**Proposed Changes to the
Current Technical Specifications**

3/4.4.3 REACTOR COOLANT SYSTEM LEAKAGE

**Proposed Changes to Improved
Technical Specification Conversion
Submittal (IP Letter U-602196)**

3.4.7 RCS Leakage Detection Instrumentation

LCO 3.4.7 The following RCS leakage detection instrumentation shall be OPERABLE:

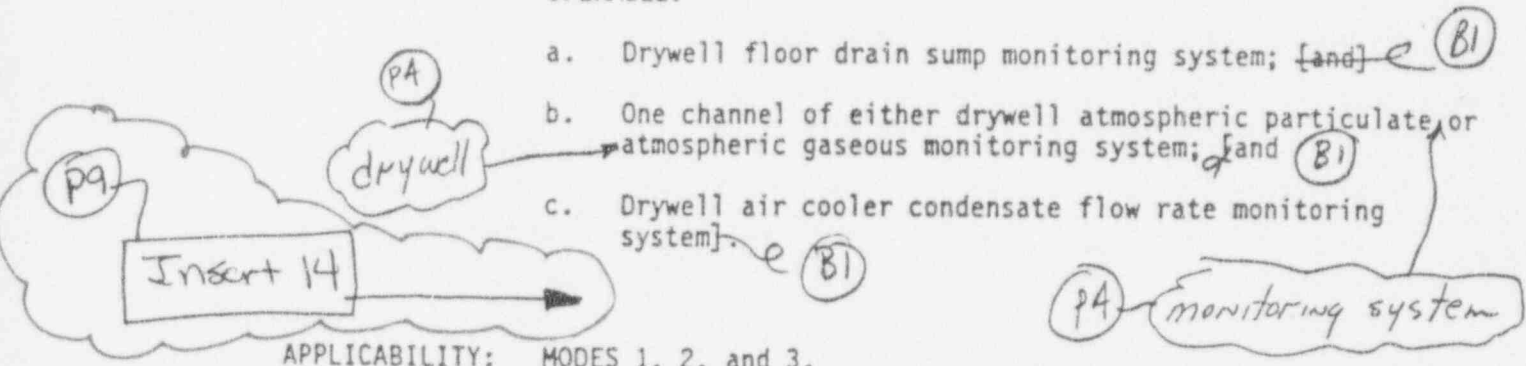
- a. Drywell floor drain sump monitoring system; [~~and~~] e (B1)
- b. One channel of either drywell atmospheric particulate or atmospheric gaseous monitoring system; [~~and~~] e (B1)
- c. Drywell air cooler condensate flow rate monitoring system] e (B1)
